### ► (ALL) MBE 900 / 4000 Serial Number Break Information

**No.: 09 TS-11**  
April 21, 2009

SUBJECT: **MBE 4000 Cylinder Head And Head Gasket Information**

**No.: 08 TS-8Rev**  
February 29, 2008

**Figure 1 – MBE 4000 Cylinder Head Recess and Head Gasket Grommet**

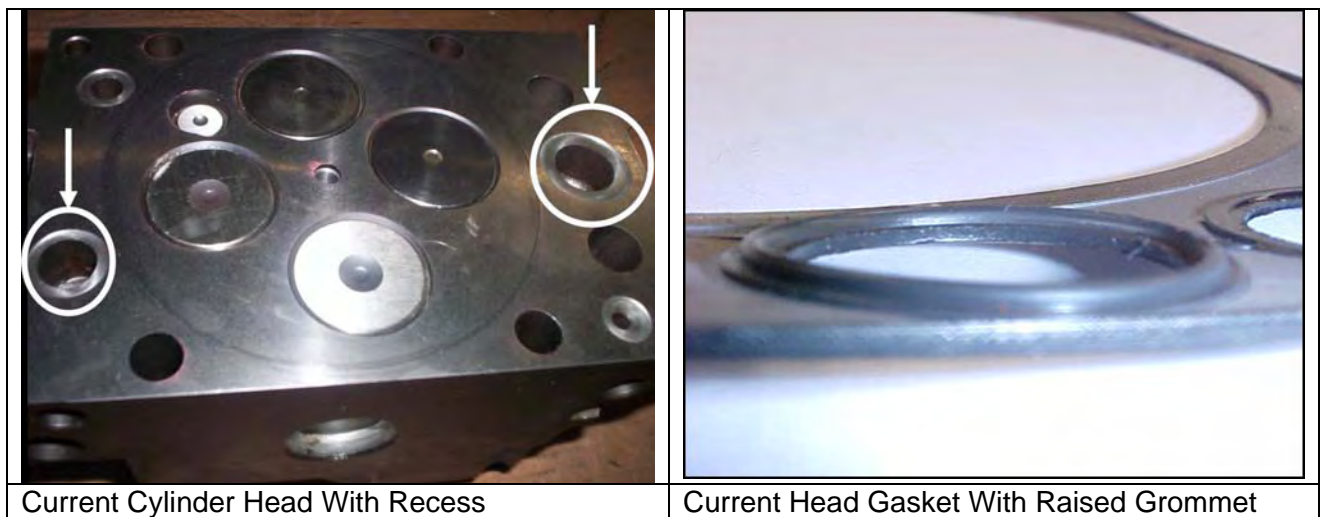
A recessed grommet sealing area was machined around each coolant inlet and outlet port in the cylinder head to give a better mating surface for the thicker rubber seal in the head gasket. See Figure 1. The new cylinder head and gasket became effective with engine S/N: 0460866443 built on August 1, 2006.

- Grommet style cylinder heads and gaskets **MUST** be used together on the same cylinder. Do NOT mix grommet and non-grommet style cylinder heads and gaskets on the same cylinder.
- Grommet and non-grommet style cylinder heads and gaskets can be used in the same engine provided they are matched as noted above. Do NOT replace all six cylinder heads and gaskets simply to have all the same new parts on the engine.
- Reference Technical Service letter [09 TS-9](#) for more information.

**Figure 2 – MBE 4000 Cylinder Head Cup Plug**

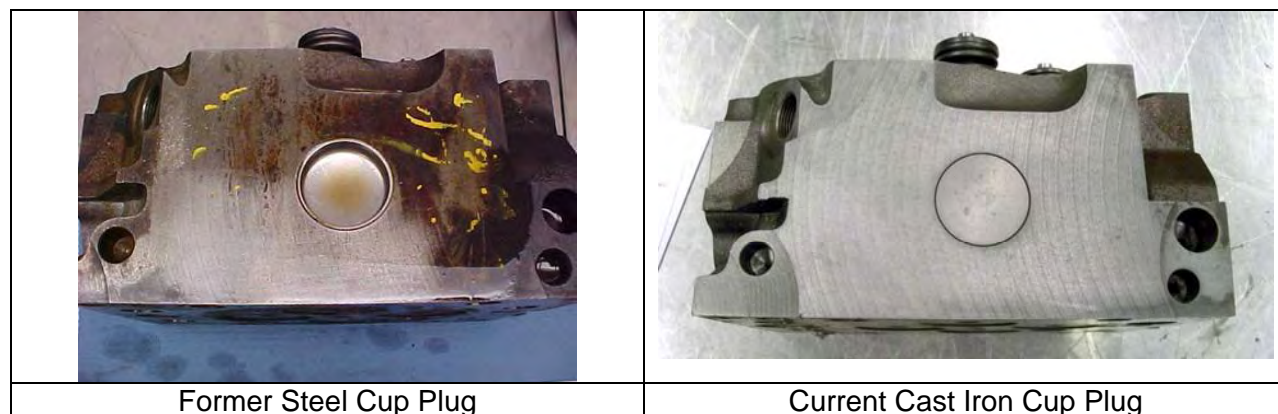
Further improvements to the cylinder head is a change to a cast iron cup plug instead of a steel cup plug to prevent head cracking. See Figure 2. The new cylinder head became effective with engine S/N: 0460884866 built on April 25<sup>th</sup>, 2007.

**Figure 3 – MBE 4000 Cylinder Head Gasket Vent Gap**

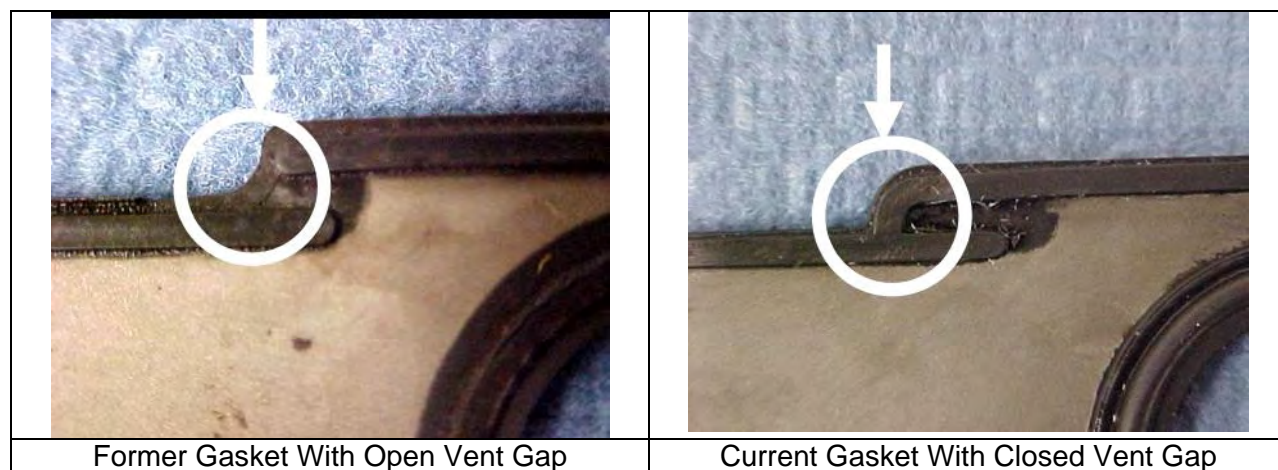
Another improvement to the head gasket includes the removal of the vent gap around the perimeter of the gasket. This will prevent water intrusion under the gasket which can cause rusting and pitting of the fire deck surfaces of the cylinder block and head, but ultimately does not affect the sealing surfaces. See Figure 3. The new cylinder head gasket became effective with engine S/N: 0460896913 built on September 3<sup>rd</sup>, 2007.

Figure 1 – Leakage in the Counterbore Area

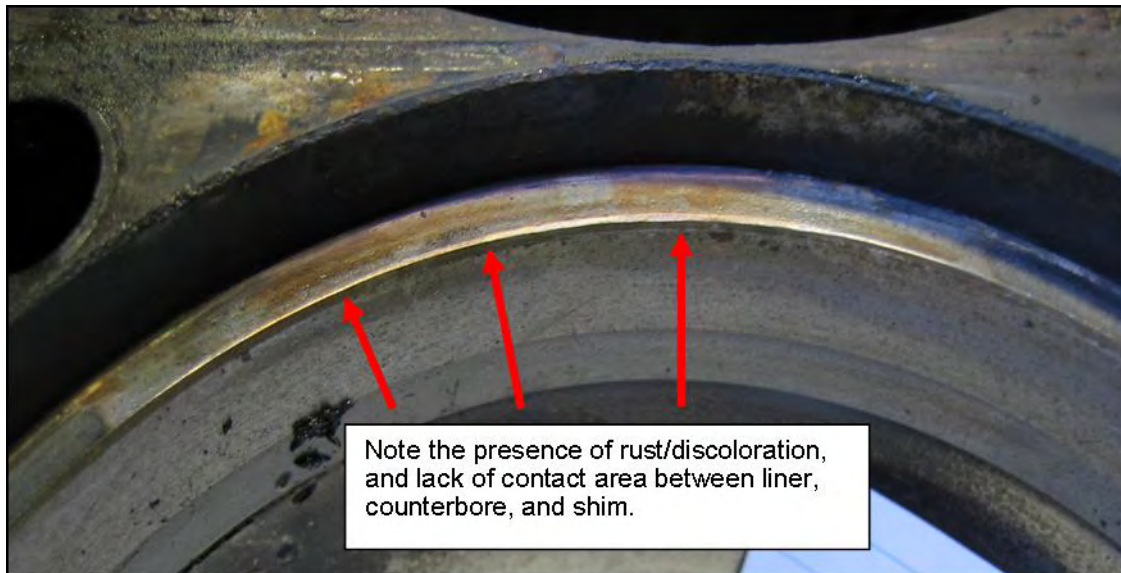
The current stainless steel shim installed between the cylinder liner and cylinder block counterbore area cannot adequately seal out coolant in this area. The coolant acts as a lubricant, causing movement between the cylinder liner and cylinder block and subsequent wear in the counterbore area. Coolant will then leak past the counterbore area. See below for pictures showing the affected areas.

- Only the **FAILED** cylinders should have their counterbores cut. This decision is based on the condition of the cylinder block counterbore sealing area. See Figures 1-3 on pages 1 and 2 for examples of failed counterbores.

Figure 4 – New Design Cylinder Liner and D-ring Seal

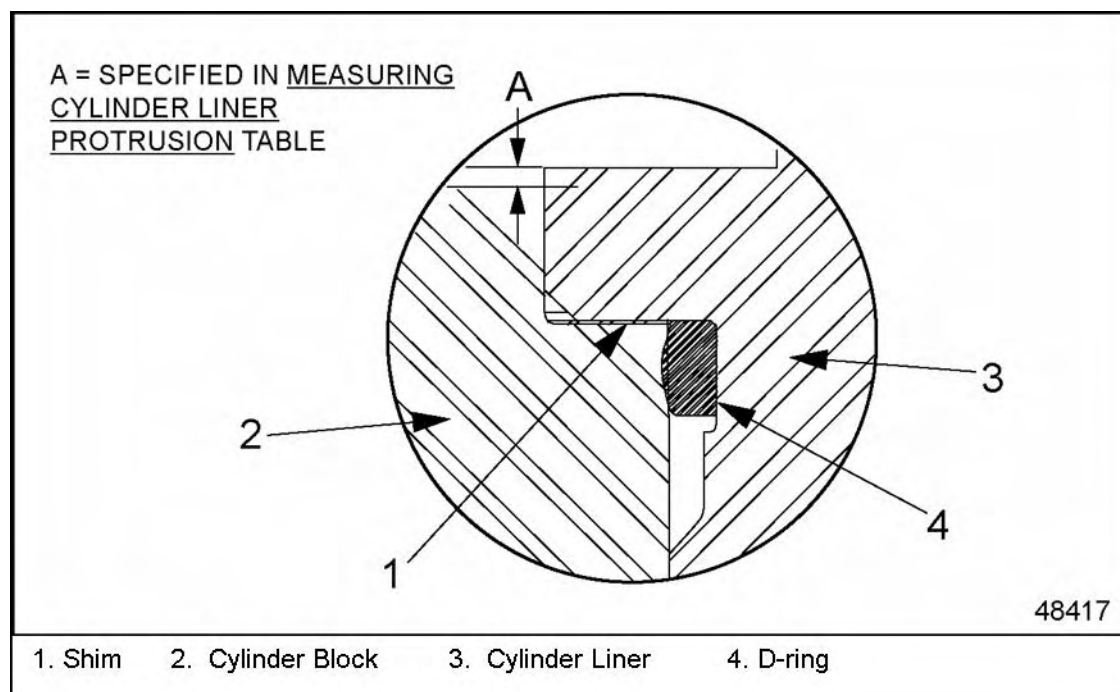
To seal the counterbore area from coolant and prevent liner movement, Detroit Diesel has released a new cylinder liner design which uses an additional rubber D-ring just below the liner flange to seal against the coolant. See Figure 4.

- Install the new D-ring to the cylinder liner. Make sure the D-ring is installed dry with the flat surface against the vertical face of the liner. See Figure 4 above, and SIB [08 MBE 4000-1Rev \(EPA07\)](#) and SIB [08 MBE 4000-1Rev \(EPA04\)](#). Be careful not to over-stretch the D-ring when it is installed over the liner flange.

**Figure 1** Brake Assembly

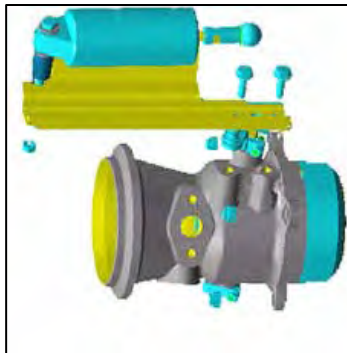
A new service assembly (P/N: R4571401206) is now available to install a REMAN MBE 4000 brake assembly, see Figure 1. This assembly can be used to address engines with braking performance issues without replacing the complete turbocharger assembly, see Figure 2. This new service assembly is compatible with 4601400171, 4601400271 and 4571400071—parts no longer serviced.

**Figure 1** REMAN Turbo Brake Assembly

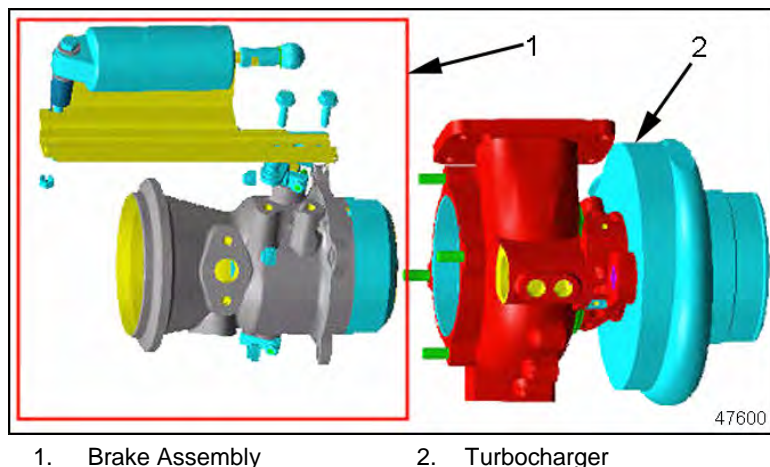
A new service assembly (P/N: R4571401206) is now available to install a REMAN MBE 4000 brake assembly, see Figure 1, No.1. This assembly can be used to address engines with braking performance complaints without replacing the complete turbo brake assembly.
